Subject: MHI's Responses to US-APWR DCD RAI No.609-4762 Revision 2

**Responses to Request for Additional Information No.609-4762
Revision 2**

RAI NO.: NO. 609-4762 REVISION 2
SRP SECTION: 19 – Probabilistic Risk Assessment and Severe Accident Evaluation
APPLICATION SECTION: 19
DATE OF RAI ISSUE: 07/20/2010

QUESTION NO. : 19-441

Figure 19.441-1 Postulated Water Level

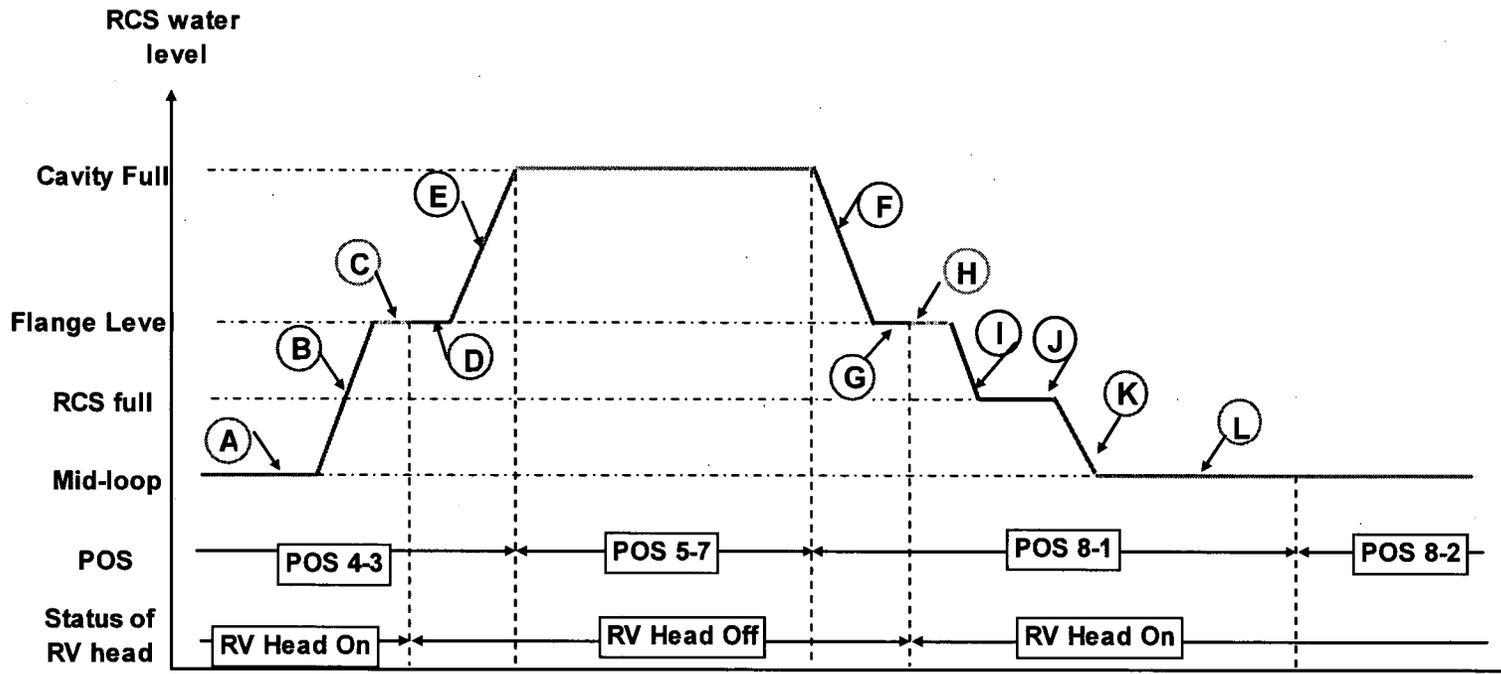
The staff has found that two plant operational states (POSS) were missing from the POS evaluation in Section 20.1.2 of the PRA and page 19-103 of the US-APWR DCD. The staff does not have enough information to conclude that POS 8-1, midloop after refueling, is bounding for the low power/shutdown (LPSD) PRA. These two plant POSSs include:

- (1) the RCS starts at midloop and is filled for refueling. This POS includes reactor vessel head removal. When the reactor vessel head is removed, the RCS water level is typically a foot below the reactor vessel flange. Since this plant operational state occurs before refueling, the time to RCS boiling can be under thirty minutes in operating plants.
- (2) the RCS is initially filled and is drained to midloop conditions after refueling. This POS includes reactor vessel head installation. When the vessel head is installed, the RCS water level is typically a foot below the reactor vessel flange resulting in reduced times to RCS boiling.

The staff is requesting MHI to quantitatively assess these POSSs separately, or justify why these POSSs are bounded by POS 8-1. If these two POSSs are bounded by POS 8-1:

- (1) the duration of time in these POSSs should be added to POS 8-1.
 - (2) the duration of time in these POSSs should be included in each initiating event frequency calculation for POS 8-1 which includes internal events, fires, and floods.
-

The current LPSD PRA model includes the duration time to change the RCS inventory; however, the definition of POS 4-3 (keep and increase of the RCS inventory) and POS 8-1 (decrease and keep of the RCS inventory) is not adequate. MHI will revise the definition to clarify the plant state and the PRA model

will remain unchanged. The following provides the basis that the current PRA model is correct using the figure and table:

The postulated outage schedule in this LPSD PRA, focused between POS 4-3 and POS 8-1, is shown in Figure 19.441-1 and Table 19.441-1.

POS 4-3 has originally been defined to include 5 plant configurations described in Table 19.441-1 (POS 4-3 A to POS 4-3 E). Duration has been assumed taking into account these plant configurations. As a result, duration of POS 4-3 has been assumed to be 6 hours in this LPSD PRA.

POS 8-1 has originally been defined to include 7 plant configurations described in Table 19.441-1 (POS 8-1 F to POS 8-1 L). Duration has been assumed taking into account these plant configurations. As a result, duration of POS 8-1 has been assumed to be 55.5 hours in this LPSD PRA.

In fact, POS 4-3 and POS 8-1 have been modeled by the representative and most severe plant configurations among several conditions in each POS. In case of POS 4-3, there is the possibility of failure of water level to maintain (FLML) in POS 4-3 A where the RCS inventory is controlled by chemical and volume control system (CVCS). POS 4-3 A has been selected as a representative and severe condition due to the highest decay heat, the lowest loop level and the maximum number of initiating events. In case of POS 8-1, there is also the possibility of over-drain (OVDR) or FLML in POS 8-1 I, J, K and L where the RCS inventory controlled by CVCS and the possibility of FLML is considered in the OVDR event. POS 8-1 I, J, K and L have been selected as representative and severe conditions due to the lowest loop level and the maximum number of initiating events. POS 8-1 has the longest duration time in all POSs, has impact on the risk during LPSD operation and has been identified as the representative POS.

In conclusion, the current LPSD PRA model can be kept because even if these POSs are considered separately in detail, the result seems to hardly change by the selection of appropriate representative POS.
